**Rio Mesa Solar Electric Generating Facility (RMSEGF)
(11-AFC-4)
Applicant's Specific Comments on the Preliminary Staff Assessment**

VISUAL RESOURCES

SPECIFIC COMMENTS

Figure 1 – Several Major Population Centers in Relation to Project Power Towers

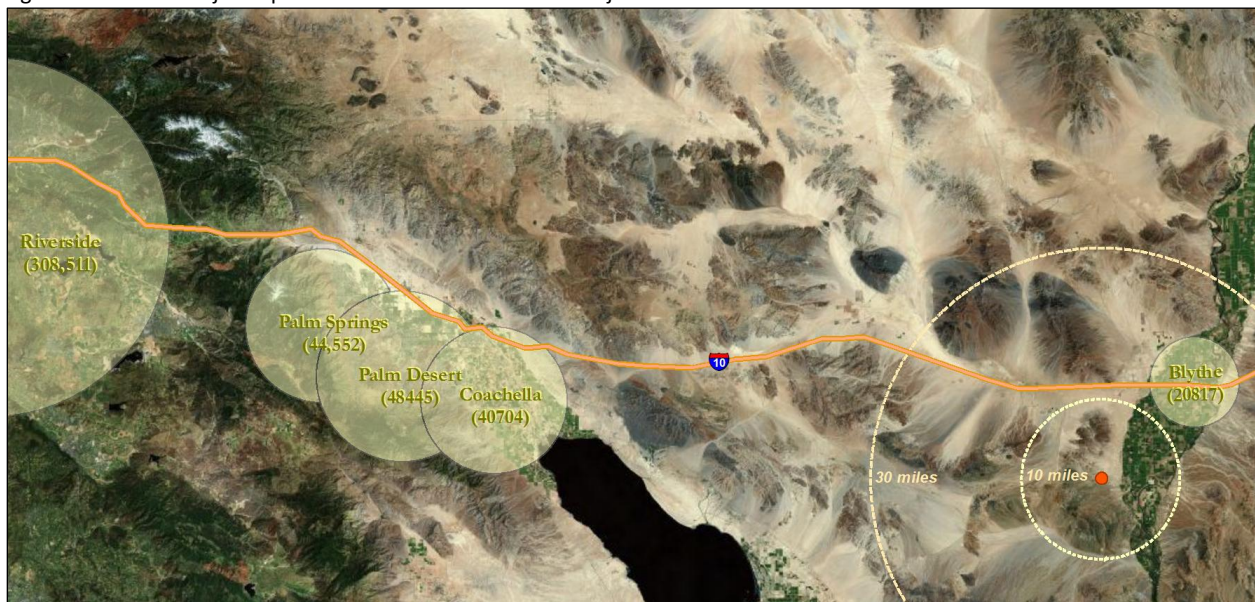
In each of the findings for viewer sensitivity, we suggest adding a description to the impact determination to acknowledge the relative limited amount of exposure (as a factor of population) that the Project would receive. Then compare this figure to other population centers both within Riverside County specifically, and then as a measure of the combined population of Riverside and Imperial Counties. This speaks to the flaw in the analytical method which fails to clearly establish the applicable threshold to measure at what level of exposure (as a measure of population) an impact becomes significant (See Appendix *Visual Resources* 2). The PSA does not disclose the scale used to characterize the number of viewers as low, medium or high. It is important to view the context of the population that surrounds the Project within the Palo Verde Valley and greater Riverside and Imperial Counties as this demonstrates the comparatively low level of population that exists within 10 and 20 miles of the project as compared to more densely populated regions of those counties. As such, the information below is presented for context and should be incorporated into the FSA in order to set a proper context for Staff’s impact analysis.
